SYDNEY NORTH PLANNING PANEL COUNCIL ASSESSMENT REPORT

Panel Reference	2017SNH082
DA Number	DA2017/1183
LGA	Northern Beaches Council
Proposed Development	Demolition works and construction of a Mixed Use Development, comprising retail shops and shop top housing
Street Address	Lot 1 DP 710661, 2 Delmar Parade, Dee Why
Applicant	2dpd Pty Ltd
Owner	Margaret Mary Wells Simon Andrew Wykeham Wells Timothy William Wykeham Wells Peter Guilford Leonard Yvette Maree Leonard
Date of DA lodgement	4 December 2017
Number of Submissions	23 Submissions
Recommendation	Refusal
Regional Development Criteria (Schedule 7 of the SEPP) State and Regional Development) 2011	Development with a Capital Investment Value (CIV) of more than \$20 million Total Cost of the Development is \$20,303,314.00 (Application lodged prior to 1 March 2018)
List of all relevant s4.15(1)(a) matters	<ul style="list-style-type: none"> • Environmental Planning and Assessment Act 1979 • Environmental Planning and Assessment Regulation 2000 • State Environmental Planning Policy No. 55 – Remediation of Land • State Environmental Planning Policy (Building Sustainability Index: BASIX) • State Environmental Planning Policy – Infrastruc

Figure 4 – The proposed building height plane (source: Adapted by the author from Plans, prepared by Marchese Partners)

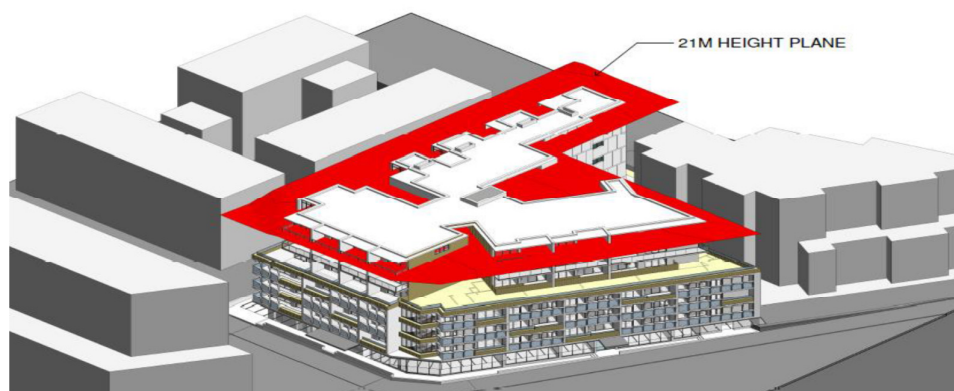
The development proposes a building height of 23.7m above the existing ground level which represents a variation of 2.7m or 12.85% to the building height standard, which equates to an additional storey of units.

The proposed lift overrun also contravenes the Height of Buildings development standard measured at 23.78m (RL52.050) equating to a 13% variation to the standard.

The approval of such a significant variation will create an undesirable precedent by encouraging other developments, which do not satisfy the podium level requirements in the Masterplan, to also exceed the height limit.

The flow-on effect of approving the proposed 24m building height, in isolation of the Masterplan, will be an erosion of both the Development Standard and the Dee Why Town Centre Masterplan.
